SERVICETEKNOTES

TABLE OF CONTENTS

The above parts are located on A38 Optical Pulse Generator board and shown on Diagram 2 OPTICAL PULSE GENERATOR - Partial

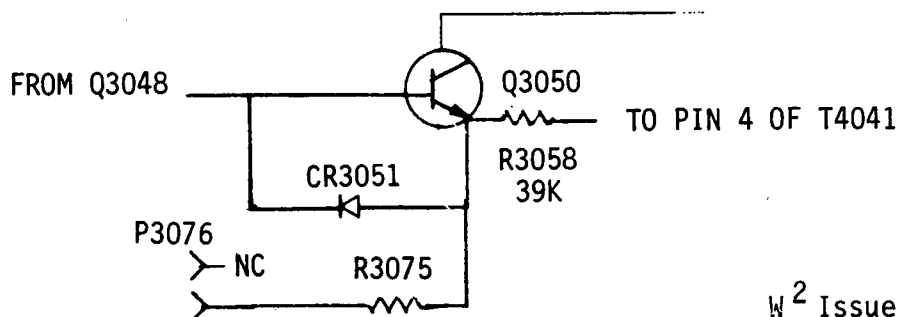
ELECTRICAL PARTS LIST AND SCHEMATIC CHANGES

CHANGE TO:

A38C2053	290-0523-00	CAP., FXD, ELCTLT: 2.2UF, 20%, 20V
A38R3046	321-0304-00	RES., FXD, FILM; 14.3K OHM, 1%, 0.125W
A38R3050	321-0246-00	RES., FXD, FILM: 3.57K OHM, 1%, 0.125W

ADD:

A38R3058	315-0393-00	RES., FXD, FILM: 39K OHM, 5%, 0.25W
----------	-------------	-------------------------------------

475, MANUAL ERROR ON POWER DISTRIBUTION
DIAGRAM

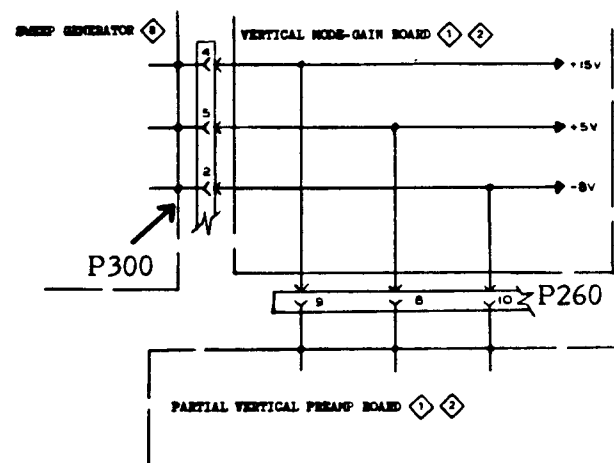
The power distribution diagram in the early 475 manual, below B250000, has an error in the power supply voltages shown on the Vertical mode--gain board. The diagram below shows the correct pin numbers and voltages.

P300, shown at the left edge of diagram 3, should be changed to show the + 5 V going to pin 5.

Change power connections on P300 and P260 as follows:

Use P/N
212-0613-00

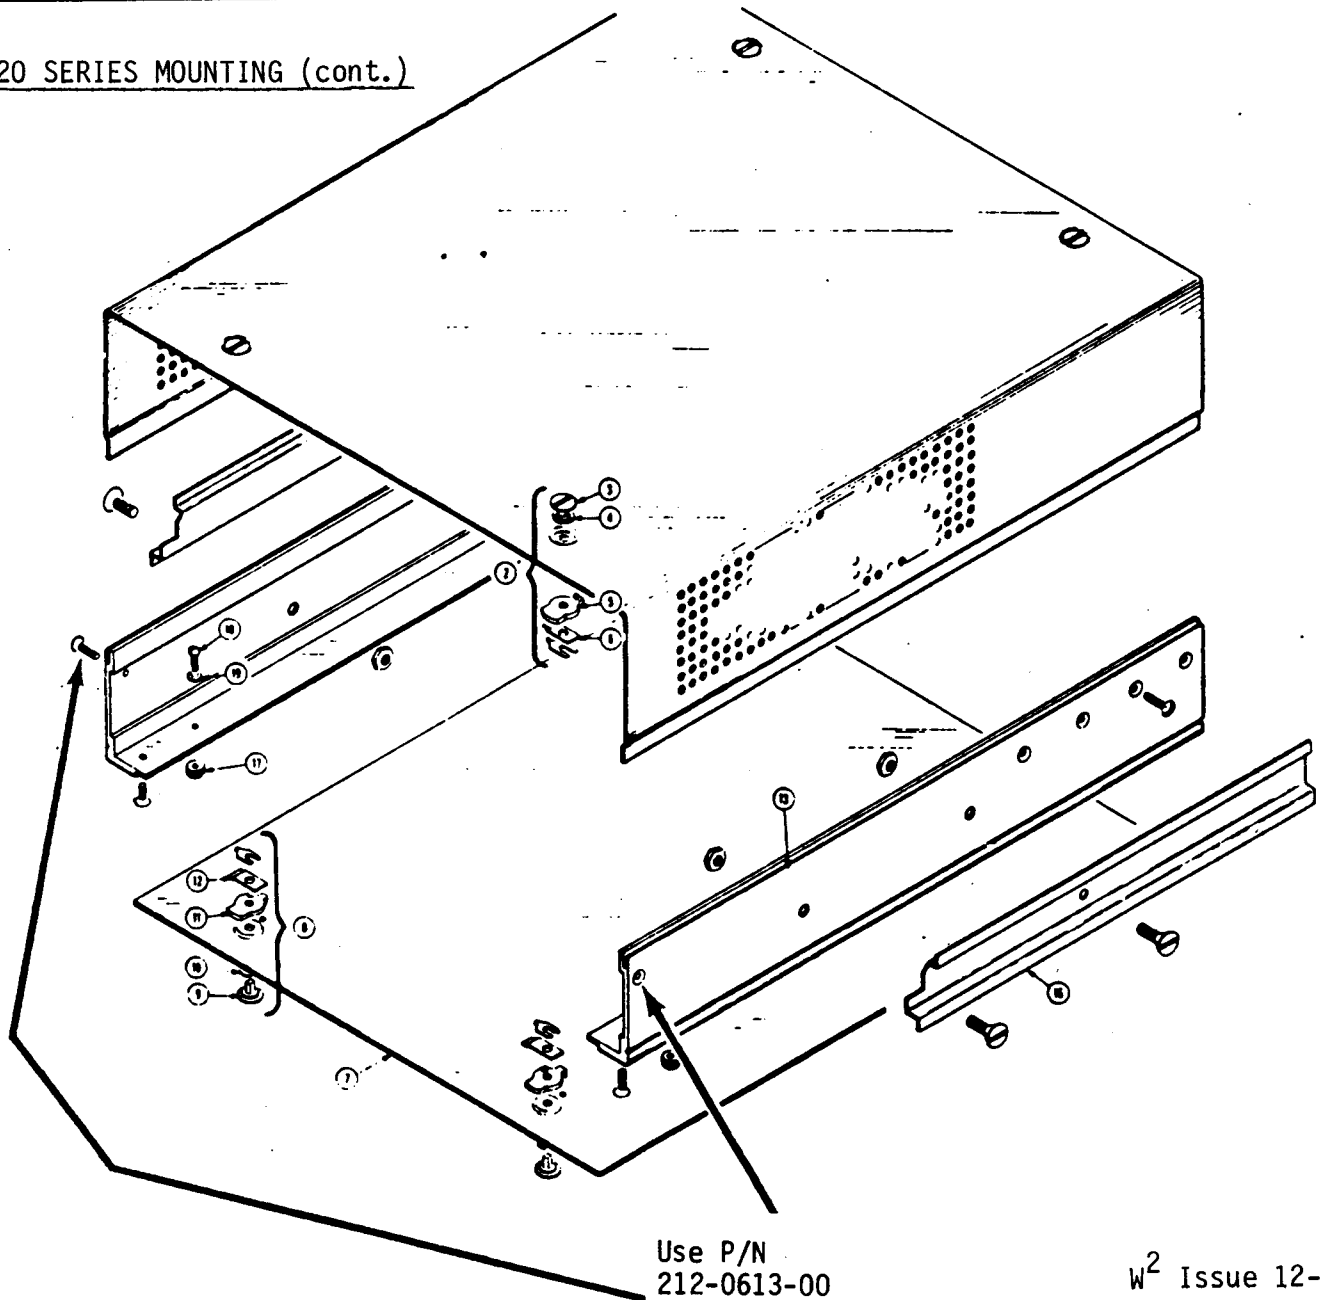
A screw of insufficient length has been used to fasten the side rails to the main chassis, causing stripped threads. Where a bad screw is found, replace with 212-0613-00 (see illustration).

DECODER BOARD
670-2611-07

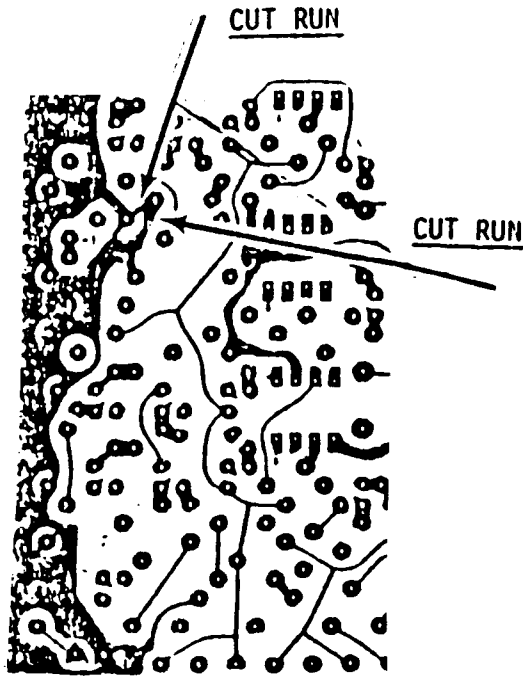
The Decoder Board (670-2611-07) has an ECB layout error which shows up as a 400KHz ripple of about 200mV P-P riding on the R-Y output. The cause is one end of R2739 being shorted to ground. The suggested fix is to cut the ground plane surrounding the bottom pad of C2641 (See illustration).

INTERIUM SOLUTION

COMPONENT SIDE OF BOARD

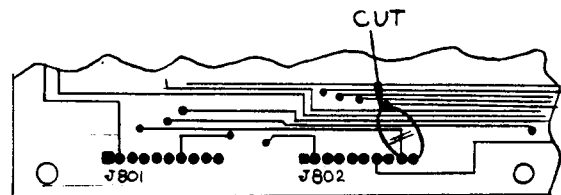
10. Connect pin 10 of J802 to pin 12 of U281.
11. Connect pin 8 of J802 to pin 19A of J301.
12. Connect pin 11 of U211 to pin 13 of U165.
13. Connect pin 11 of U165 to pin 12 of U165.
14. Cut run from pin 9 of J802. See Fig. 1

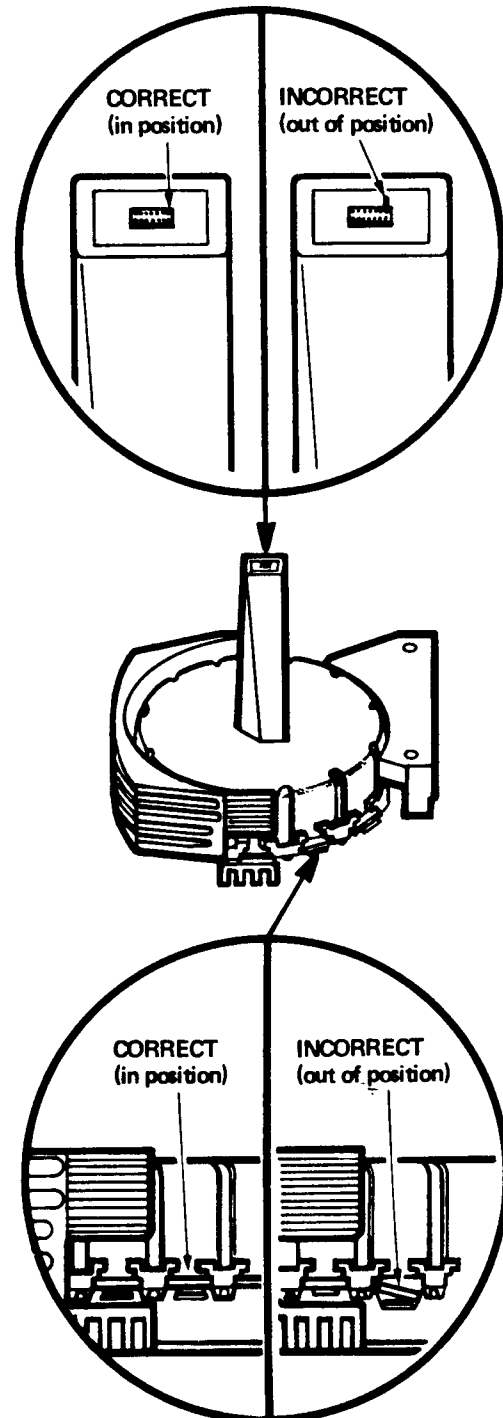
The metal plates that cause the printhead wires to move can be jarred out of position during handling or replacement.

Be sure to inspect printheads after product shipping or during printhead replacement. If a wire is protruding from the printhead, it indicates that the metal plate is lifted from its normal position. Be sure to reseat the metal plate back to its proper position. See illustration.

Figure 1

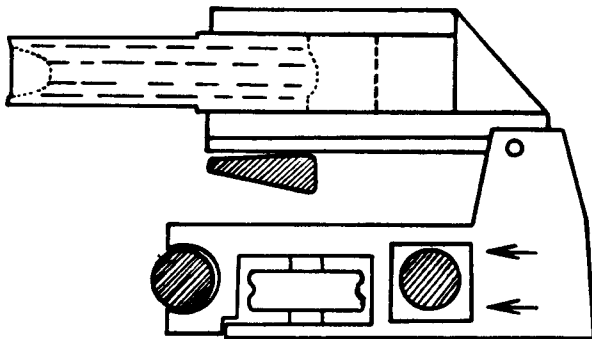
The 4662 can be visually inspected to determine if the rear of a pen carriage is positioned too high. Looking at the side of the pen carriage, observe the square hole surrounding the rear slide shaft. The slide shaft should be positioned closer to the top of the square hole. See figure 1.

Figure 2

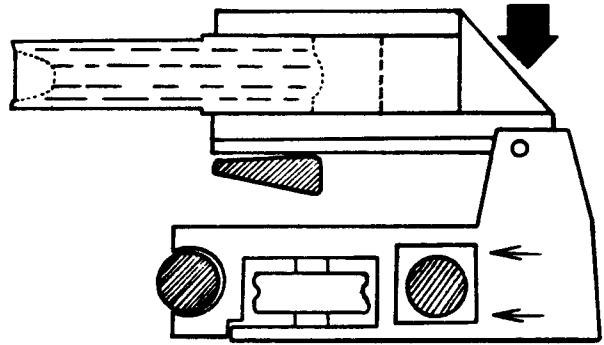
If the carriage slide shaft is located closer to the bottom of the square hole, figure 2, the pen carriage needs to be correctly positioned. This can be accomplished by placing firm downward pressure on the rear of the pen carriage just above the pivot point, see figure 2, while supporting the bottom of the carriage slide shafts to keep them from becoming bent or warped. The downward pressure should cause the pen carriage to snap back into its normal operating position.
